**Historic Architectural Review Commission
Staff Report for Item 15**

Application Number: H2024-0011

Address: 718 Southard Street

Reconstruction of a non-conforming single-family house.

1962 Sanborn map over current survey.

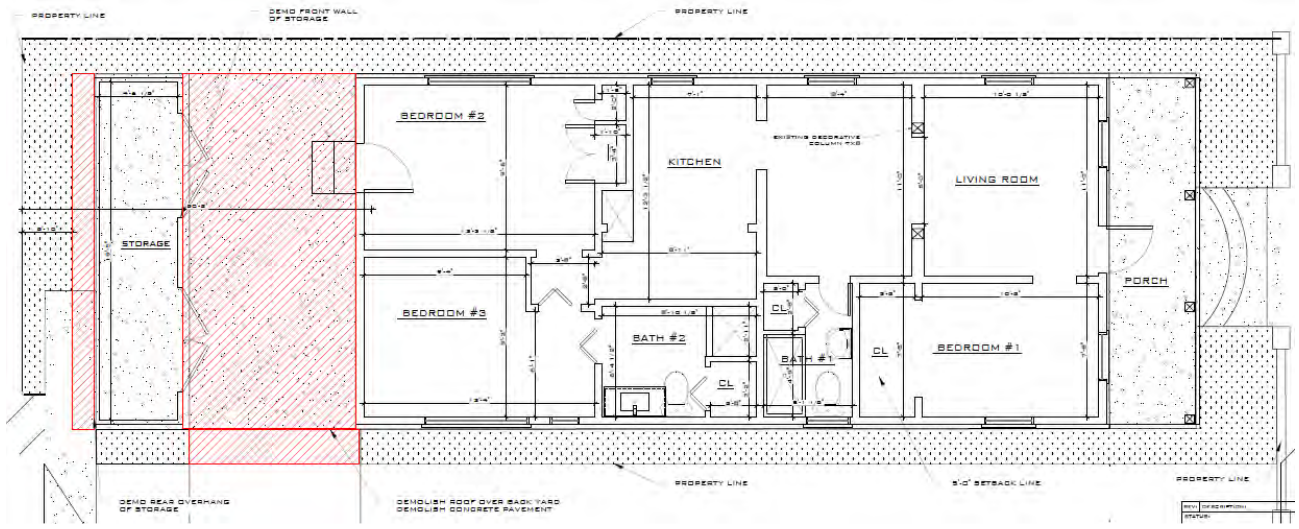
The construction will follow the existing foundation and structural flooring, overall design, roof form, window and door locations, and other features on the exterior of the house as were original. The exterior changes from the original appearance of the primary structure will generally be limited to the rear of the structure, and what had previously been an addition.

Original demolition site plan.

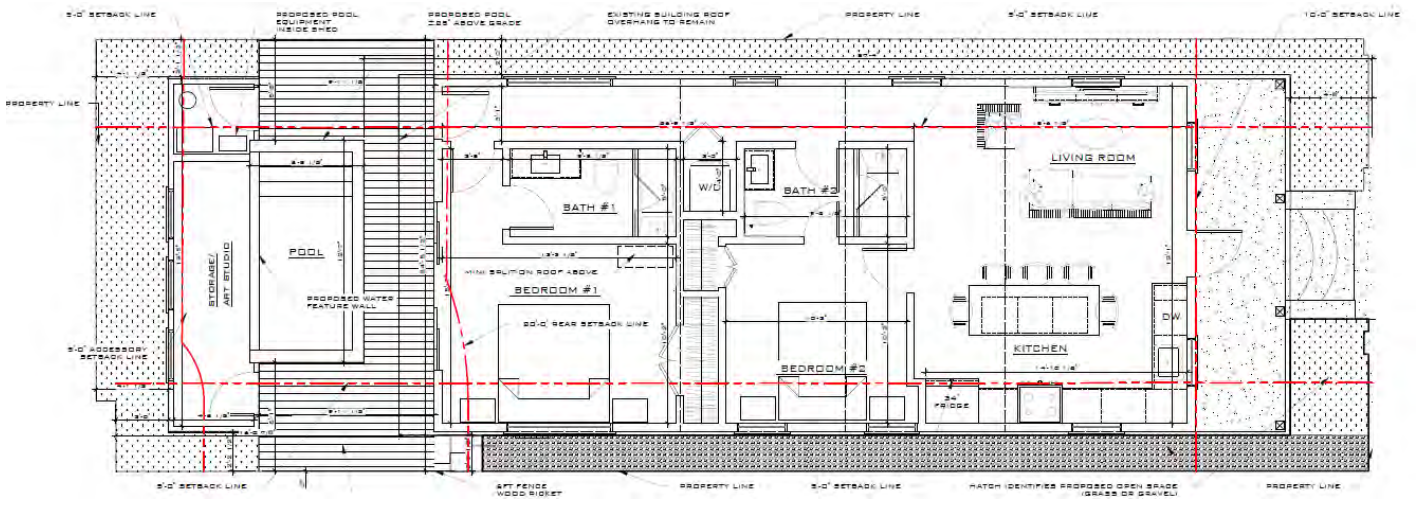
New materials will include Hardi board lap siding, a combination of wood and aluminum impact resistant windows and doors, decorative wood shutters, metal roof shingles similar to original, and wood picket fencing. At the rear, a wood frame deck approximately 2-feet, 6-inches above grade, and pool with deck surround at the same elevation are also included.

Construction of a new accessory structure or shed, along with storage for the pool equipment, is also proposed in the location of a prior accessory structure. Materials for this will be the same as the house, with the addition of brick facing the rear of house and a water feature adjacent to it. This structure was approved by the Planning Board, as at the time it required variances for minimum open space, building coverage, and impervious surface ratio.

Proposed reconstruction site) plan.

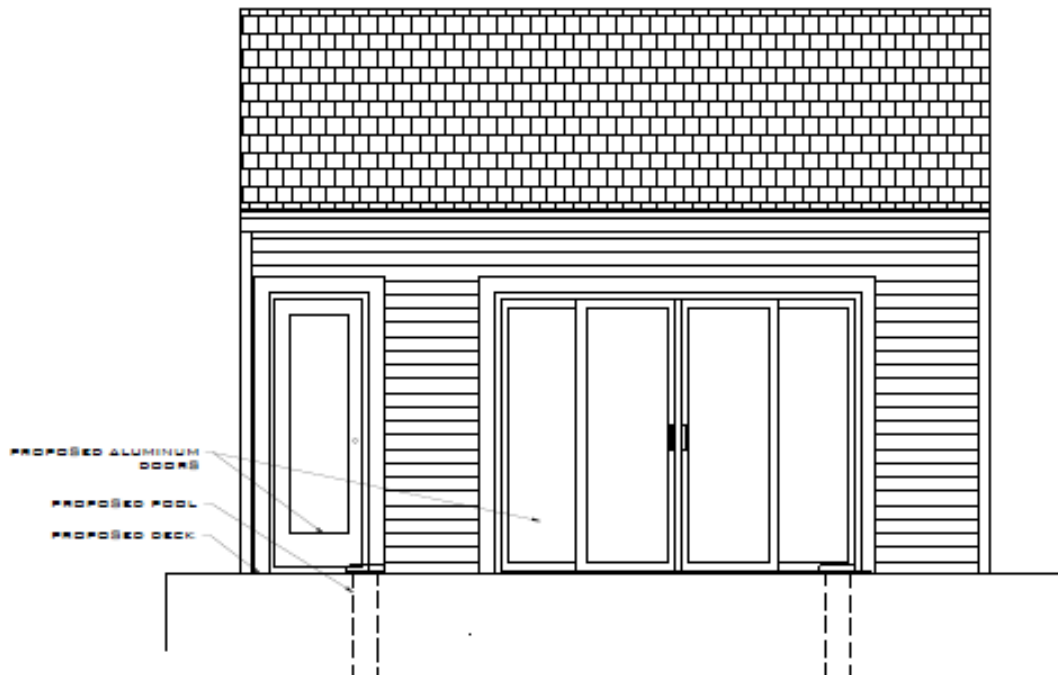
A mini split AC condenser unit is proposed behind the rear sawtooth, and new 6-foot tall picket fencing will be installed at the east elevation between the rear of the house and the rear property line.
